CITY OF ALBUQUERQUE

RE: **Lot 2 Block 10 S.A.D. 227 Unit 5**
8005 Marigold NW
Grading and Drainage Plan
Engineers Stamp Date 3/26/2021 (E10D103)

DRAINAGE AND TRANSPORTATION INFORMATION SHEET (REV 6/2018)

<div>ENGINEER'S SEAL</div> <div></div> <div>3/26/21</div> <div>DAVID SOULE P.E. #14522</div>	8005 MARIGOLD	DRAWN BY: WCVJ
	GRADING AND DRAINAGE PLAN	DATE 3-24-21
	 1606 CENTRAL AVENUE SE SUITE 201 ALBUQUERQUE, NM 87106 (505) 872-0999	210210032-LAYOUT-3-24-21 SHEET # — JOB # 21021032

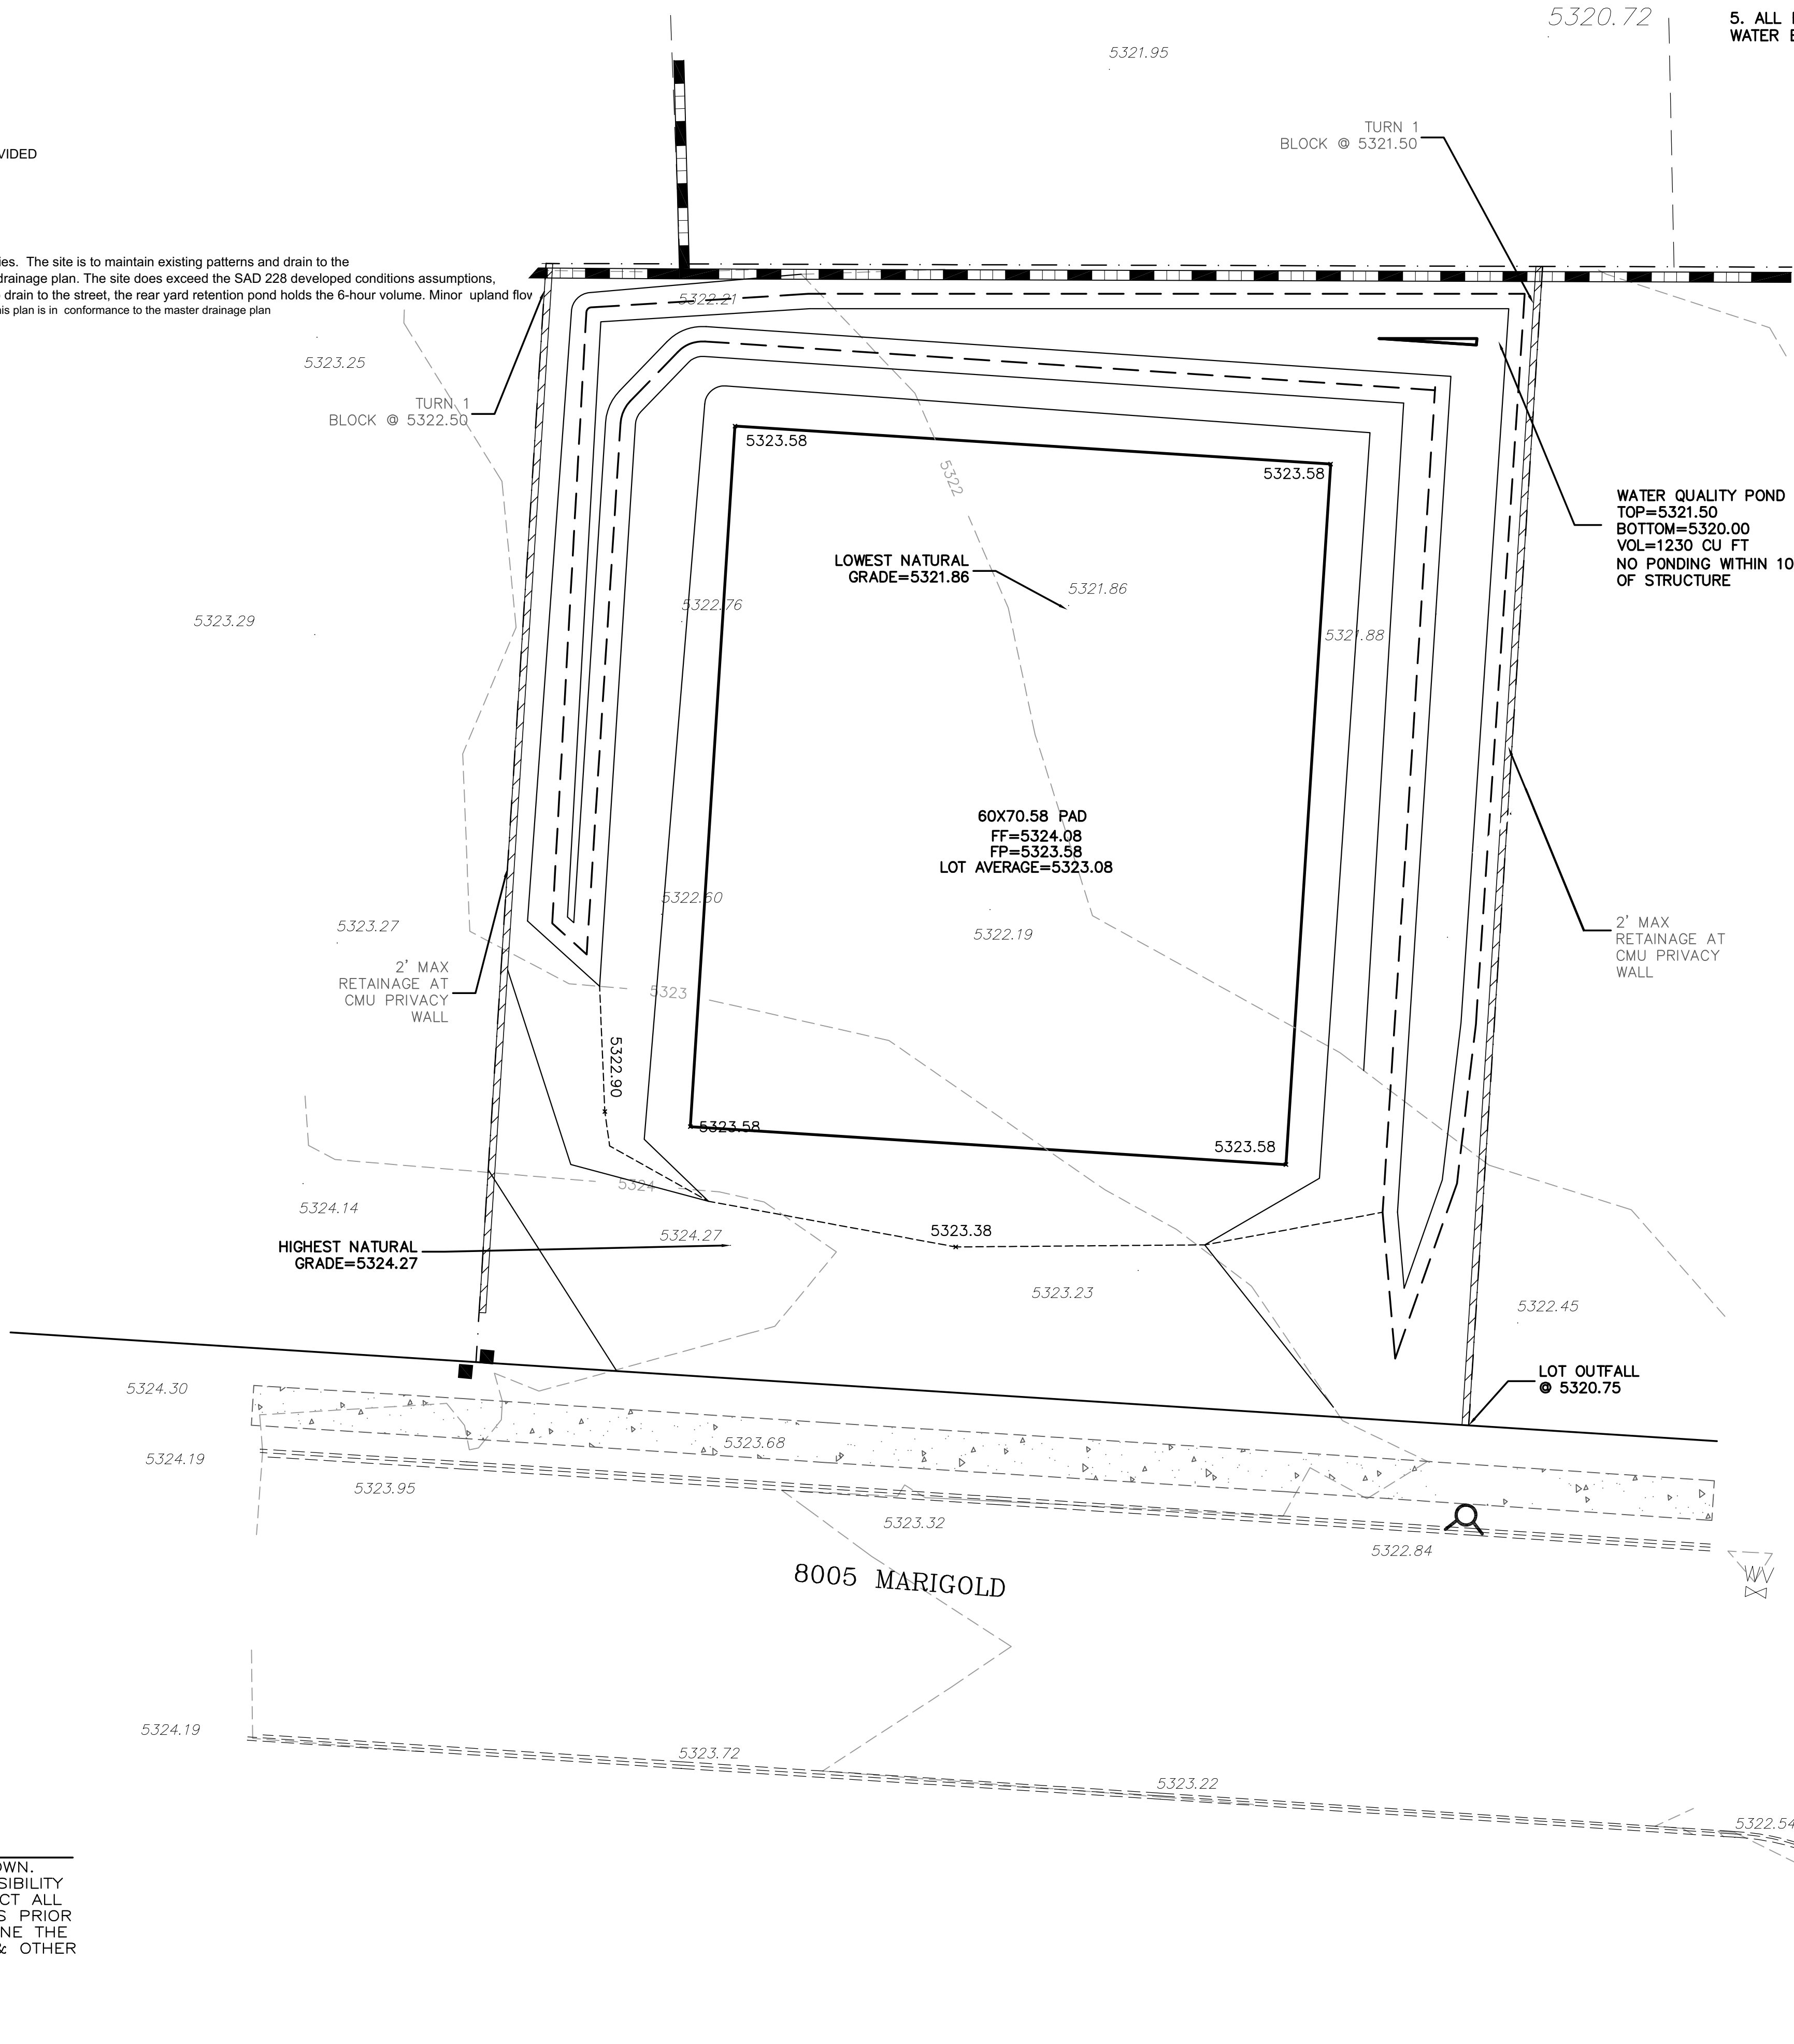
Based upon the information provided in your submittal received 3/29/2021, this plan is approved for Grading Permit. Please inform the builder/owner to attach a copy of this approved plan and letter into the construction sets in the permitting process prior to sign-off by Hydrology.

Reiterate to the Owner/Contractor that a separate permit for any garden/retaining wall must be obtained, with the approved G&D plan. Advise the owner contractor not to use dirt as a ramp to climb the curb, use lumber or crusher fines for this purpose. Also, let the owner/contractor know that if a pool is to be added in the future the G&D plan will need to be modified showing the location of the pool and the land treatment differences.

Prior to Building Permit approval, a **Pad Certification** will be required. Inform the contractor/owner not to pile dirt in the street as a ramp to climb the curb. If dirt is found in the street the pad cert. will be denied.

Prior to **Certificate of Occupancy release**, Engineer Certification per the DPM checklist of this plan will be required.
